# UNITED STATES PATENT AND TRADEMARK OFFICE

APPLICATION NO.	FILING DATE	FIRST NAMED INVENTOR	ATTORNEY DOCKET NO.	CONFIRMATION NO.
09/989,271	11/20/2001	Michael C. Smyk	FCI-2632/C3069	9590
7590	11/01/2004		EXAMINER HARVEY, JAMES R	
Andrew J. Hagerty Woodcock Washburn LLP 46th Floor One Liberty Place Philadelphia, PA 19103			ART UNIT 2833	PAPER NUMBER
DATE MAILED: 11/01/2004

## Office Action Summary

**\*\* Claim(s) 45-54 are rejected under 35 U.S.C. 102(b) as being anticipated by Foreign Patent EP 0 893 850 A2( herein after referred to as FP 850' ).**

**-- In reference to Claim(s) 45, FP 850' shows (figure 3 )**

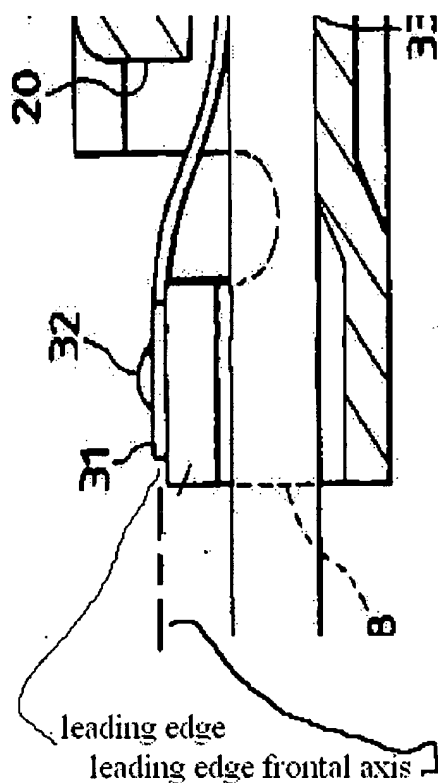
a contact section for mating with a complementary male terminal, the contact section including a bottom wall 13;

a first set of sidewalls 18 that define a first tubular portion with the bottom wall; and a second set of sidewalls 14, which are longer than the first set of sidewalls, that define a second tubular portion with the bottom wall, the second tubular portion arranged end to end with the first tubular portion; and

a flexible contact element 10 at least partially disposed within the contact section in a non-fixedly secured manner ( column 5, lines 33-37 ) for urging a complementary male terminal into engagement with the bottom wall.

-- In reference to Claim(s) 46, FP 850' shows (figure 3 ) the flexible contact element includes a leading edge (near the lead line of numeral 31 ) that is positioned outside of the contact section.

-- In reference to Claim(s) 51, FP 850' shows (cover sheet and (figure 3) an opening (near the lead line of numeral 20 ) is defined at an interface between the first tubular portion and the second tubular portion; and

-- In response to applicant's argument (page 6, line 7 ) concerning that EP 850' does not teach that the flexible contact element 30 is attached to the terminal body 11 in a *non-fixedly secured manner*, the examiner disagrees. EP 850' teaches ( column 5, line 36 ) that the spring member 30 "may be detachably mounted" on the terminal body 11. This teaching is seen to anticipate the

newly amended claim language of *non-fixedly secured* because the ability of the spring member 30 to be detached makes it not fixedly secured to the terminal.
